## Consideration of Comments

<b>Project Name:</b>	2023-03 Internal Network Security Monitoring   Draft 1
<b>Comment Period Start Date:</b>	12/14/2023
<b>Comment Period End Date:</b>	1/17/2024
<b>Associated Ballot(s):</b>	2023-03 Internal Network Security Monitoring (INSM) CIP-007-X IN 1 ST 2023-03 Internal Network Security Monitoring (INSM) CIP-007-X Non-Binding Poll IN 1 NB 2023-03 Internal Network Security Monitoring (INSM) Implementation Plan IN 1 OT

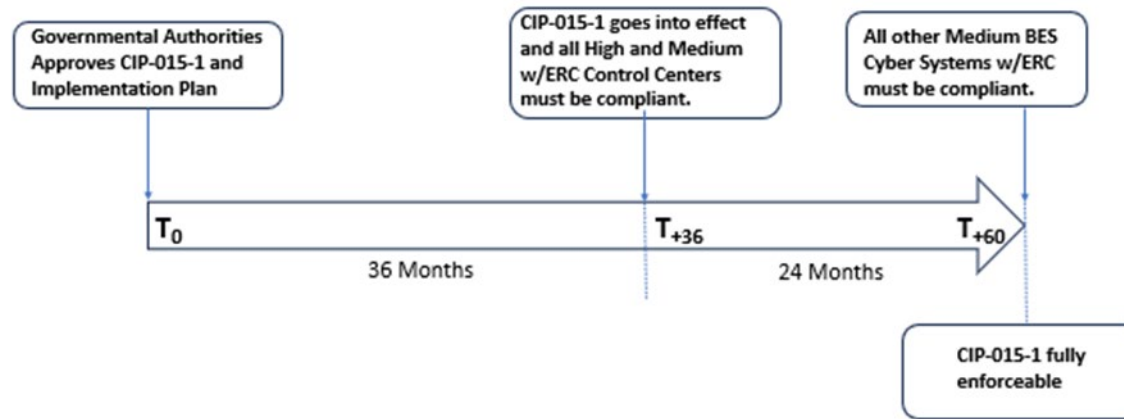
**8. Throughout proposed Requirement R6, the Project 2023-03 SDT tried to create a requirement that was objective based and allow latitude for various INSM methodologies and technologies to be used now and in the future. Do you agree that the SDT was successful in this endeavor? If you do not agree, please provide your recommendation, and if appropriate, technical or procedural justification.**

The DT appreciates all the comments received from industry and created a graph to help clarify the implementation timeframes.
